SUBJECT: ISSUANCE OF AMENDMENT NO. 73 TO FACILITY OPERATING LICENSE NPF-35
AND AMENDMENT NO. 67 TO FACILITY OPERATING LICENSE NPF-52 - CATAWBA
NUCLEAR STATION, UNITS 1 AND 2 (TACS 71477/71478)

The amendments revise TS 3/4.4.9, "Pressure/Temperature Limits," and its associated Figures 3.4-2 and 3.4-3, and Bases. The amendments also revise TS Table 4.4-5 regarding the withdrawal schedule for the reactor vessel material surveillance program.

SAFETY EVALUATION BY THE OFFICE OF NUCLEAR REACTOR REGULATION
RELATED TO AMENDMENT NO. 73 TO FACILITY OPERATING LICENSE NPF-35
AND AMENDMENT NO. 67 TO FACILITY OPERATING LICENSE NPF-52

FIGURE 3.4-2 CATAWBA NUCLEAR STATION, REACTOR COOLANT SYSTEM, HEATUP LIMITATIONS APPLICABLE FOR THE FIRST 10 EFPY

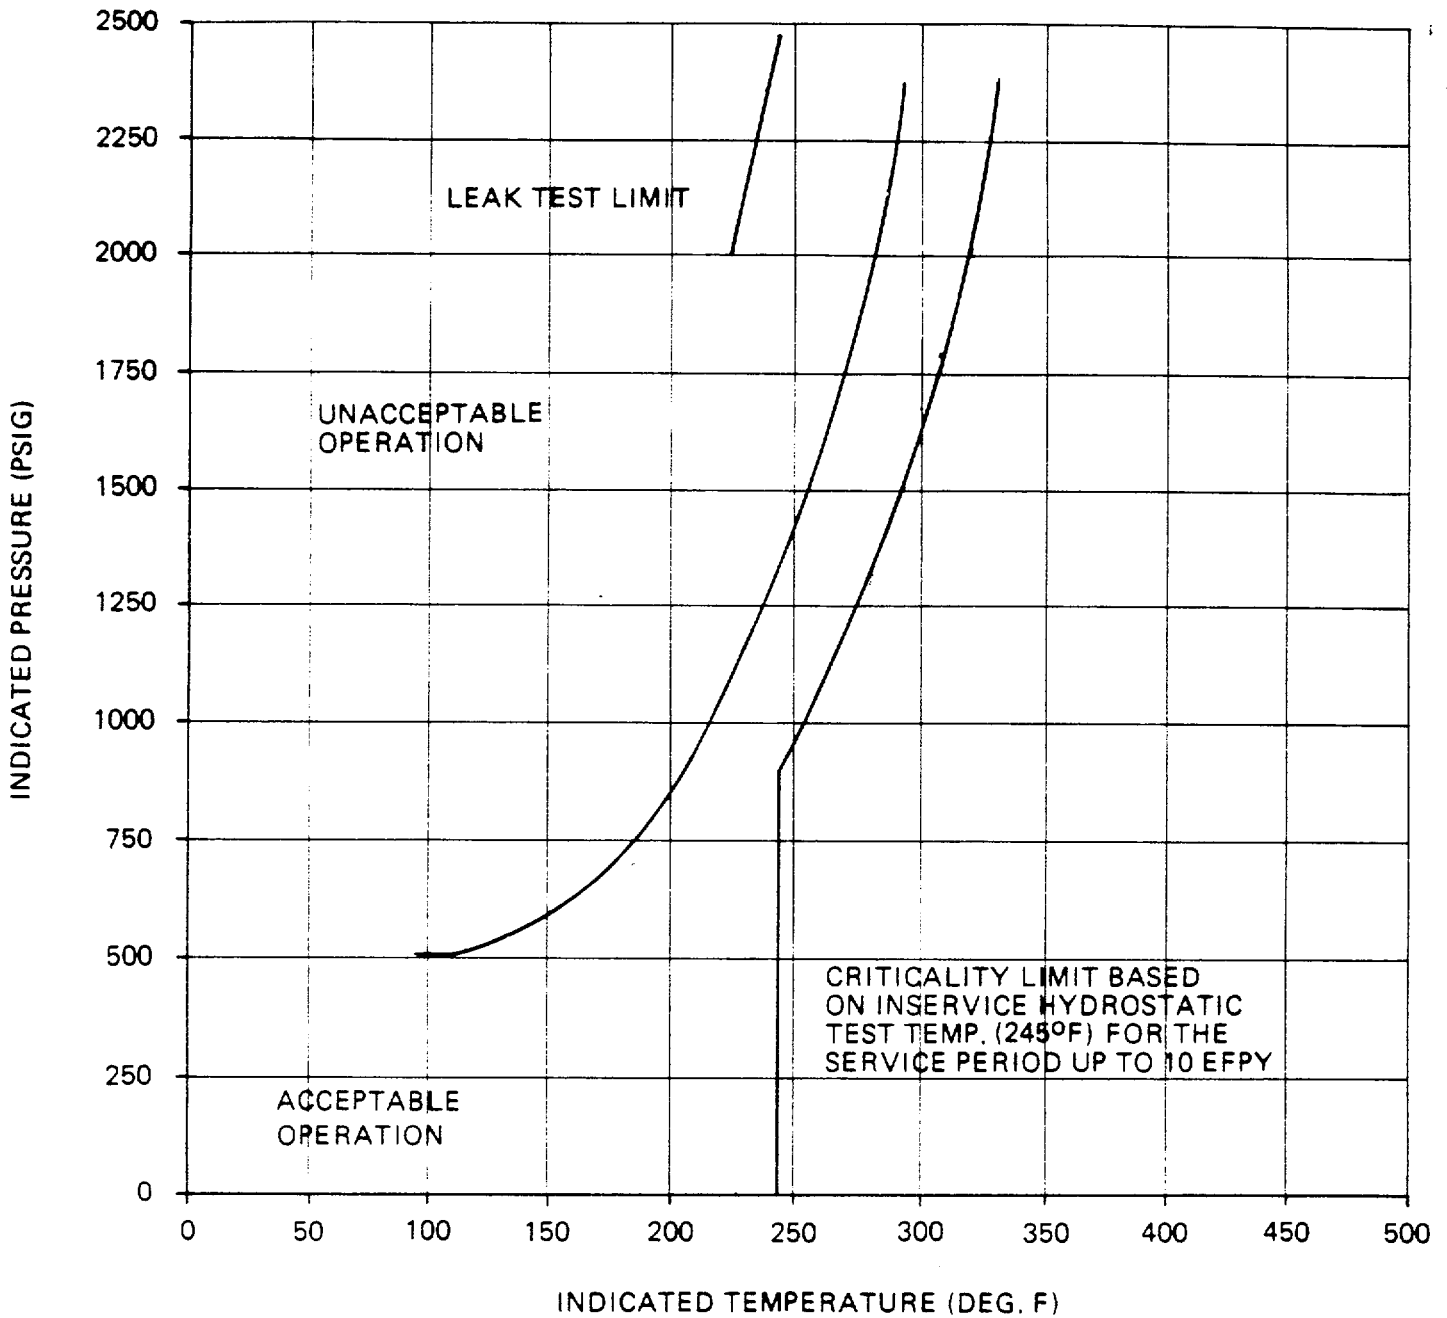
3.4.9.1 The Reactor Coolant System (except the pressurizer) temperature and pressure shall be limited in accordance with the limit lines shown on Figures 3.4-2 and 3.4-3 during heatup, cooldown, criticality, and inservice leak and hydrostatic testing with:

CURVE APPLICABLE FOR HEATUP RATES UP TO 60°F/HR FOR THE SERVICE PERIOD UP TO 10 EFPY CONTAINS MARGIN OF 10°F AND 60 PSIG FOR POSSIBLE INSTRUMENT ERRORS.

MATERIAL BASIS
 CONTROLLING MATERIAL— UNIT 2 INTERMEDIATE SHELL
 PLATE 88605-2
 COPPER CONTENT—0.07wt%
 NICKEL CONTENT— 0.81 wt %
 RT_{NDT}INITIAL—33°F
 RT_{NDT}AFTER 10 EFPY 1/4T, 104°F
 3/4T, 92°F
